**NOTICE OF A REGULAR MEETING
BONDURANT PLANNING AND ZONING COMMISSION
JUNE 24, 2021**

TITLE: RESOLUTION NO. PZ-210624-12 - Considering recommended approval of the Commerce Crossings Phase 2 site plan.

TITLE: RESOLUTION NO. PZ-210624-13 - Considering recommended approval of the Dvorak Preliminary Plat.

DVORAK SUBDIVISION PRELIMINARY PLAT

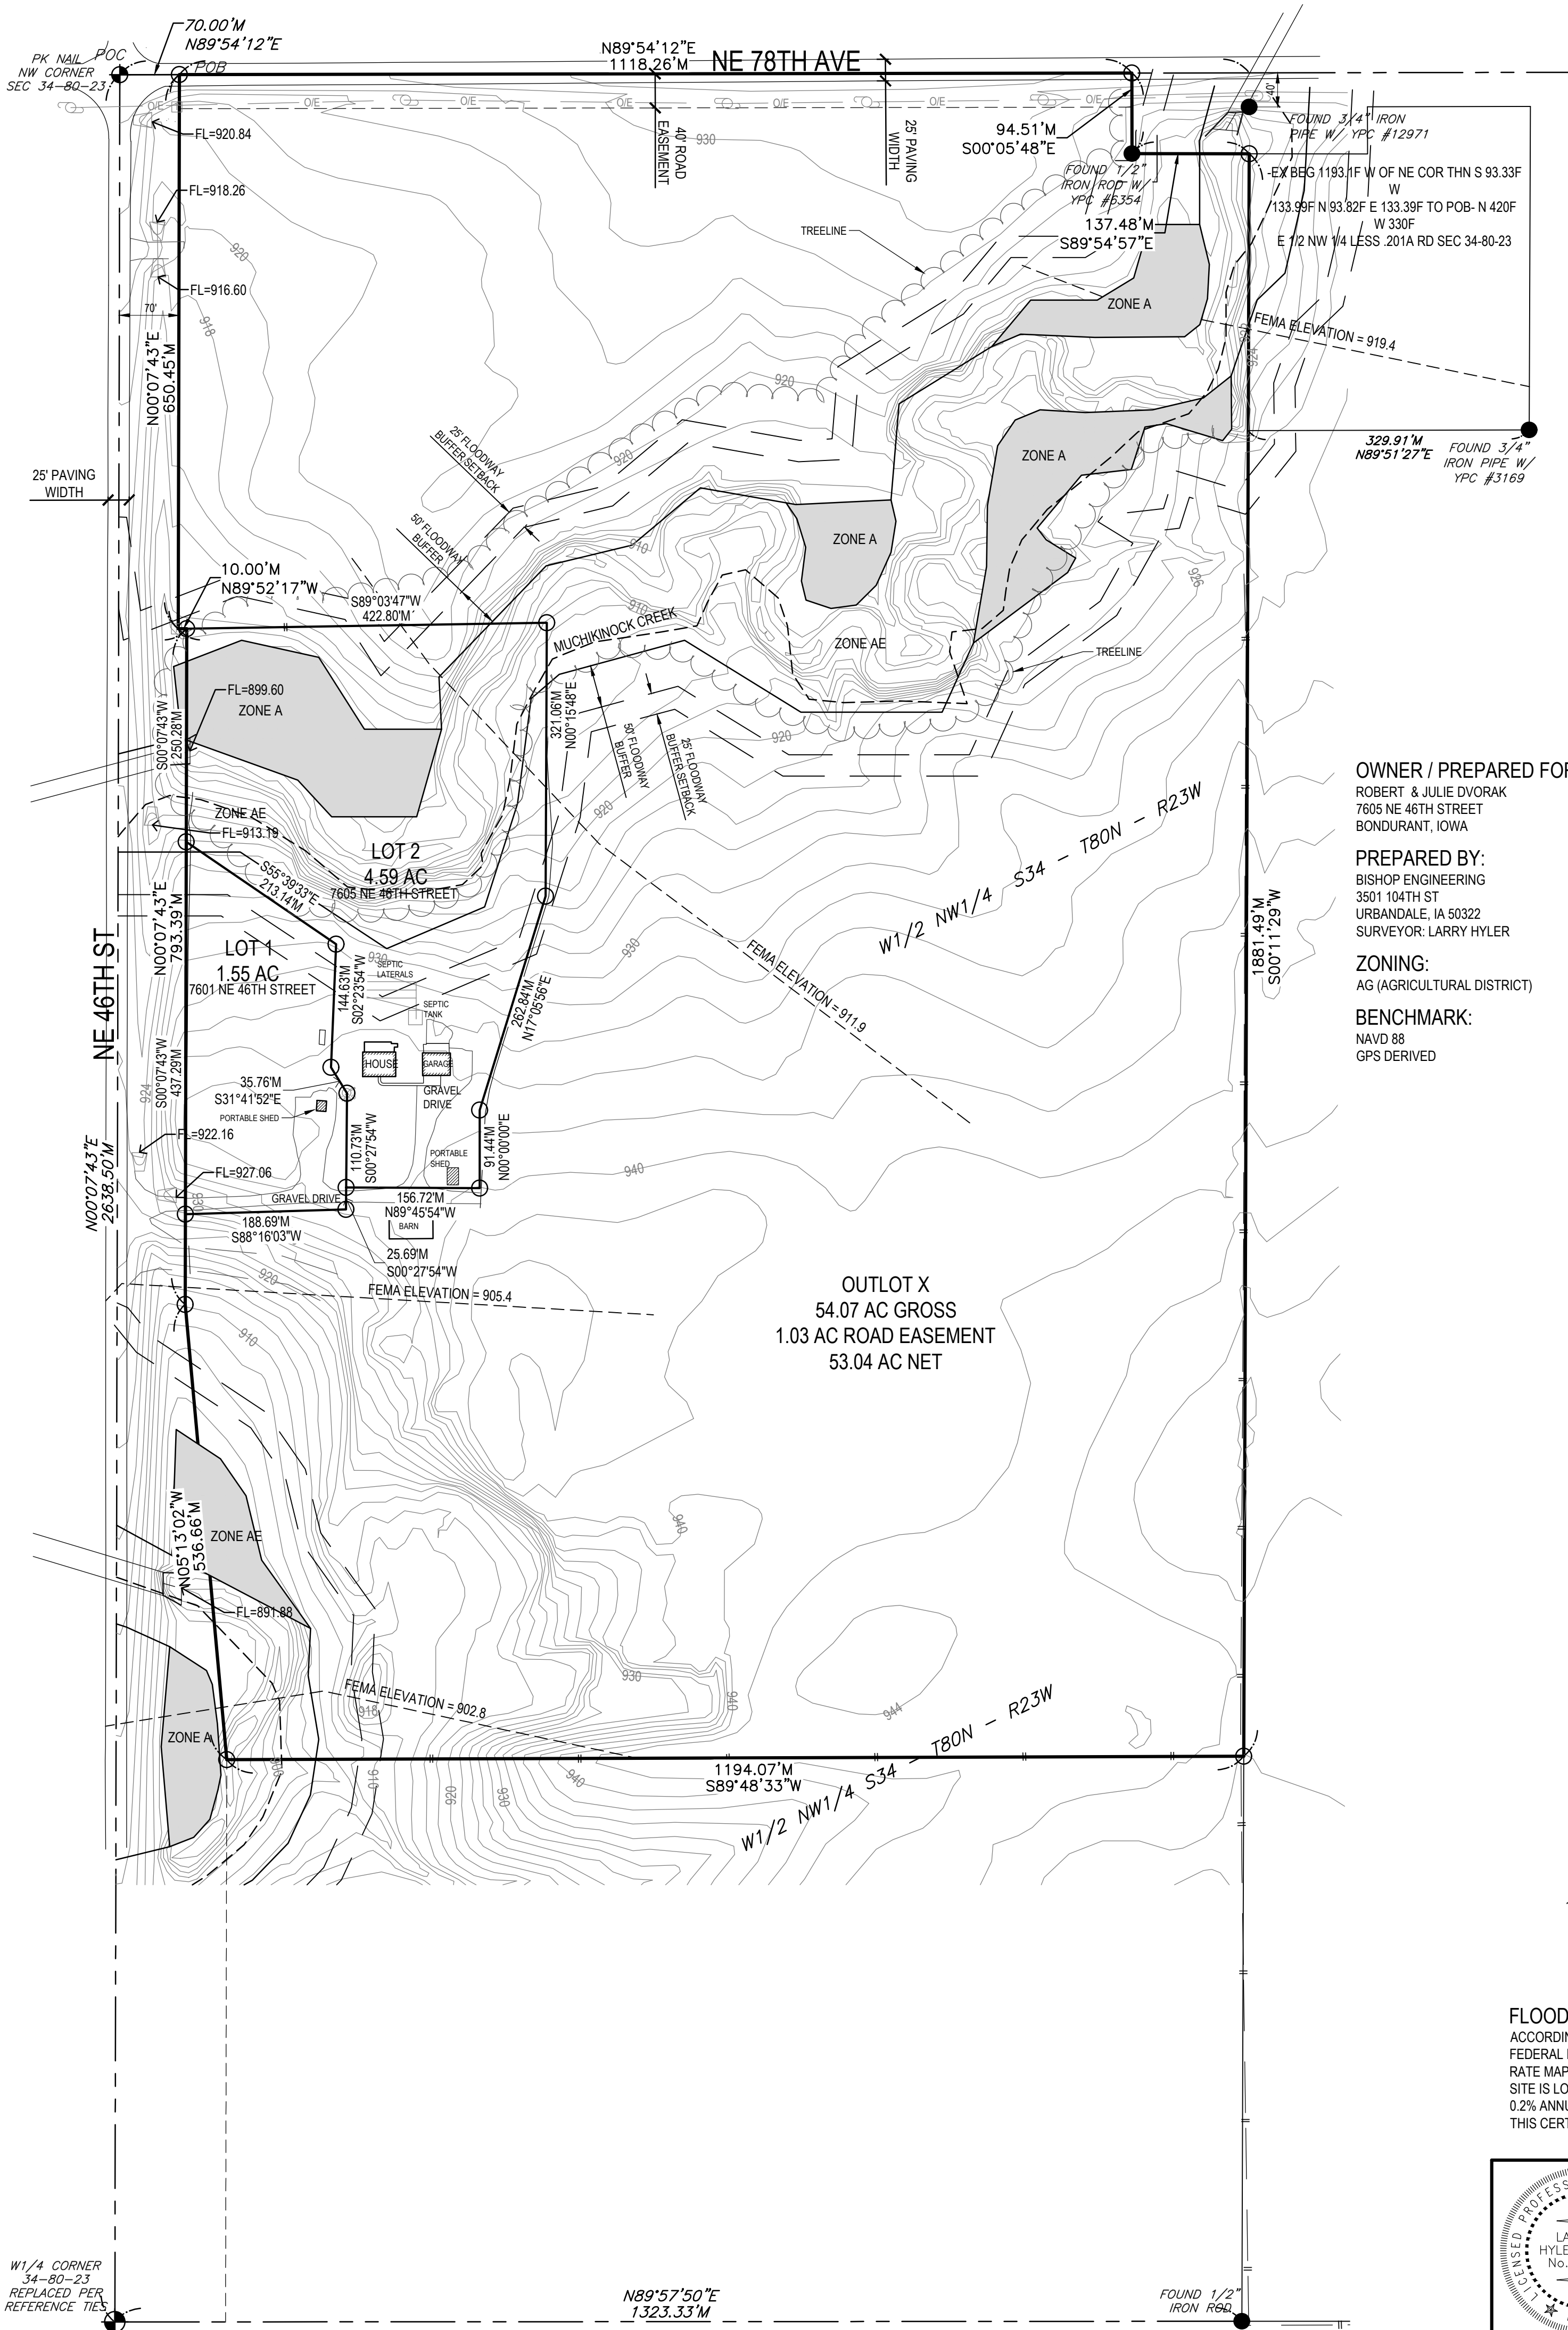
The preliminary plat shows a 40'-wide roadway easement along NE 78th Avenue. The enclosed P&Z recommendation resolution notes this must be a 50'-wide easement area to match the City's 2nd Street NW right-of-way east of this area.

1. The preliminary plat be updated to show a 50'-wide roadway easement along NE 78th Avenue.

1. That the roadway easement along NE 78th Avenue be widened to 50'.
